### Addendum No. 1

### City of Coquitlam Tender 74770 Pipeline Road Improvements

(Consists of 43 Pages) Issue Date: February 7, 2025

=	DESIGN NO	).	020	
SCALE	AS SHOWN	CREATION DATE	2424/11//01	DWG. NO.
DRAWN BY	PM	DESIGN BY	CJB	08 of
CHECKED BY	CJB	APPROVED BY	CJB	38
				rev. C

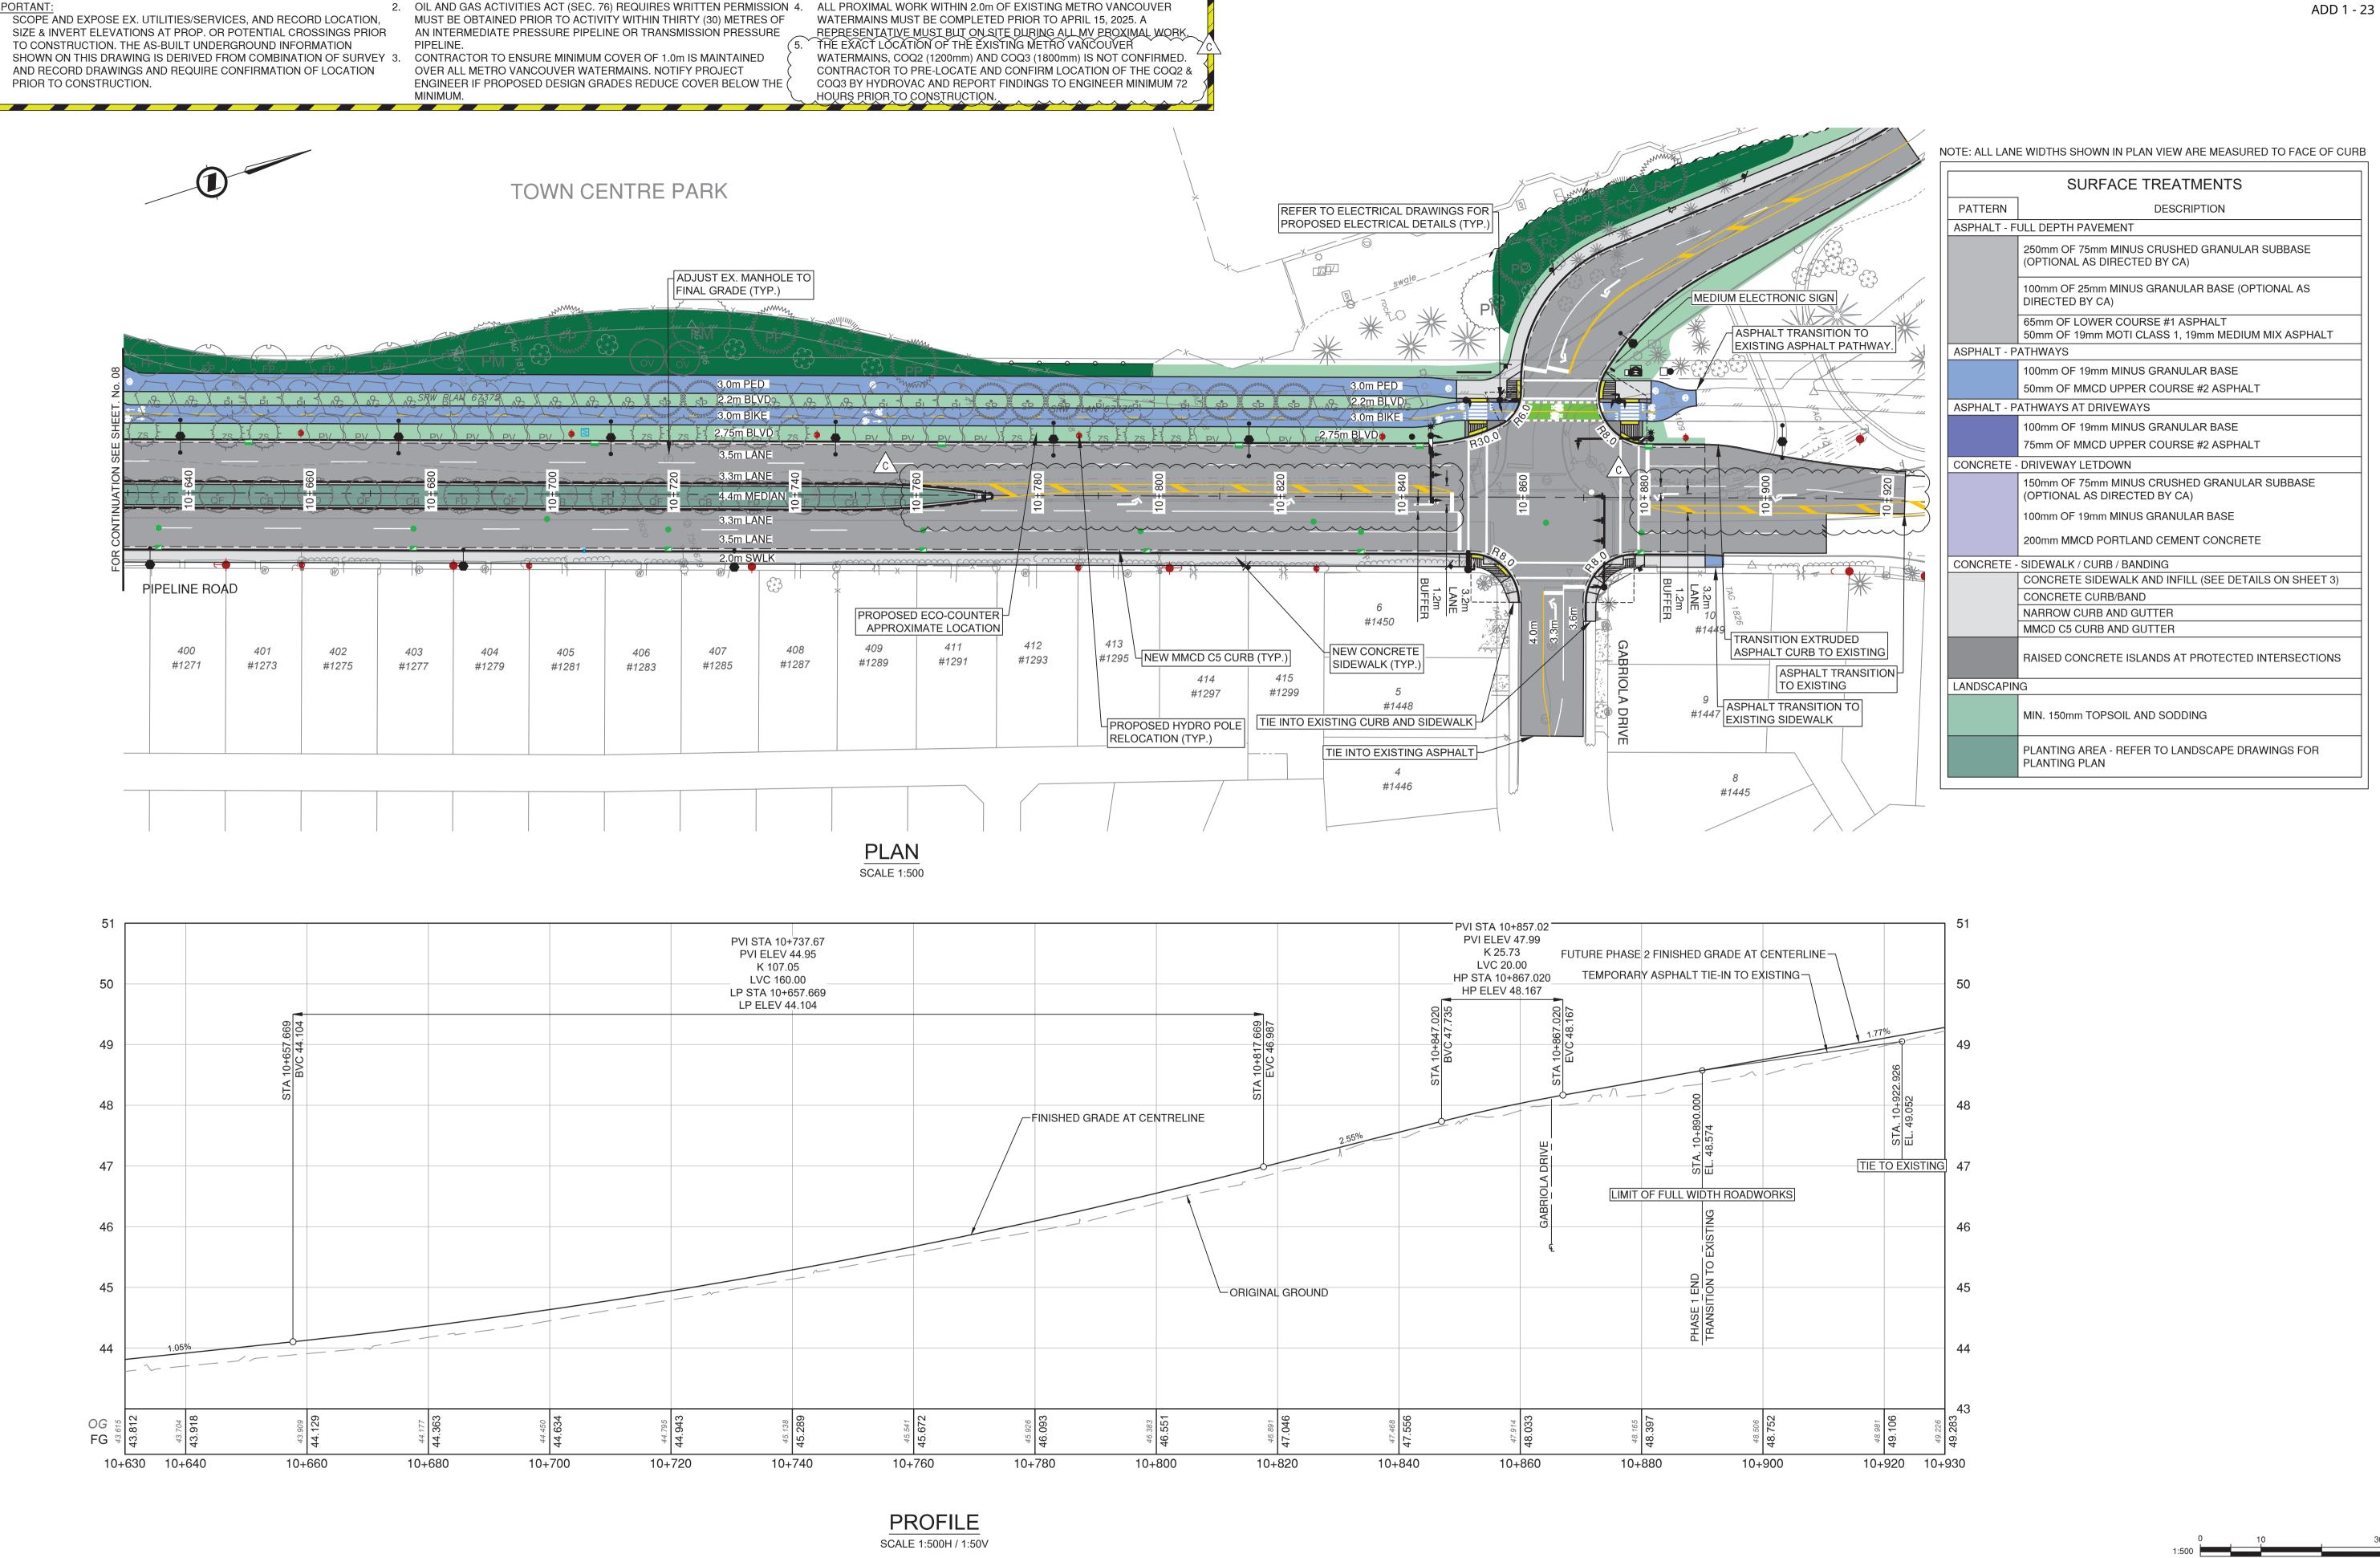
- A9) Median concrete band behind the curb will be paid under Pay Item 4.03, Section 03 30 20S, Clause 1.4.5.
- Q10) Please provide updated roadworks drawings indicating where the 150mm concrete curb/banding is required.

- A10) Refer to revised sheet 08 of 38, Rev. No. C.
- Q11) Please confirm if the 150mm concrete curb/banding will be required wherever asphalt pathway paving meets landscaping (for example, on both sides of the asphalt MUP/pedestrian walkway/bike path).
